Technical Service Bulletin: TSB101058

New KV Lubrication Oil Filter Head Gasket

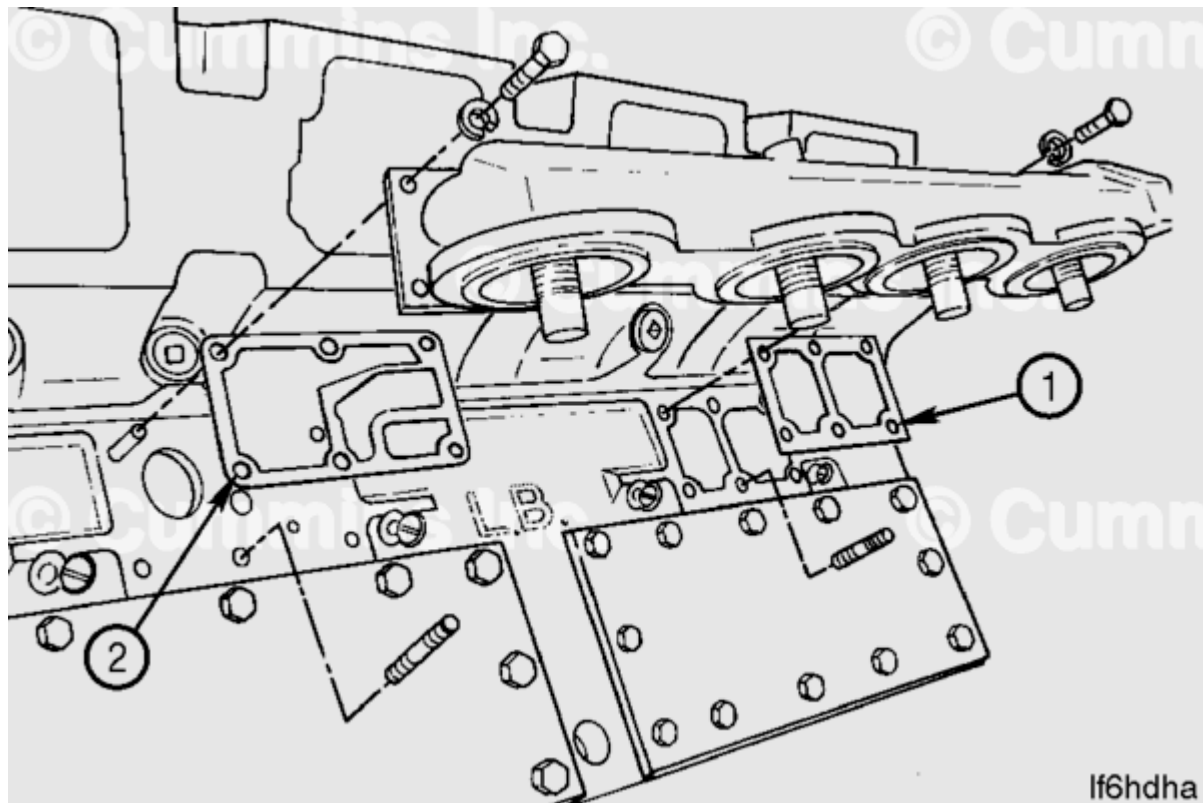
This document announces the release of a new lubricating oil filter head gasket for use on K38, K50, QSK38, and QSK50 series engines built with inboard piston cooling nozzles. The gasket material has been changed from steel core to edge molded to increase durability and to improve engine reliability. The new edge molded gasket is used for both the inlet and outlet port connections of the lubricating oil filter head.

Engines built with outboard piston cooling nozzles can **not** use the new edge molded gasket and **must** use the old steel core gaskets for the inlet (1) and outlet (2) connections of the lubricating oil filter head. This is due to the oil supply for the outboard piston cooling nozzles coming through the outlet port of the lubricating oil filter head.

Outboard Piston Cooling Nozzles			Inboard Piston Cooling Nozzles		
Item No.	Description	Old Part Number	Material	Quantity	New Part Number	Material	Quantity
1	Gasket	3629387	Steel Core	1	3643837	Edge Molded	2
2	Gasket	3177108	Steel Core	1
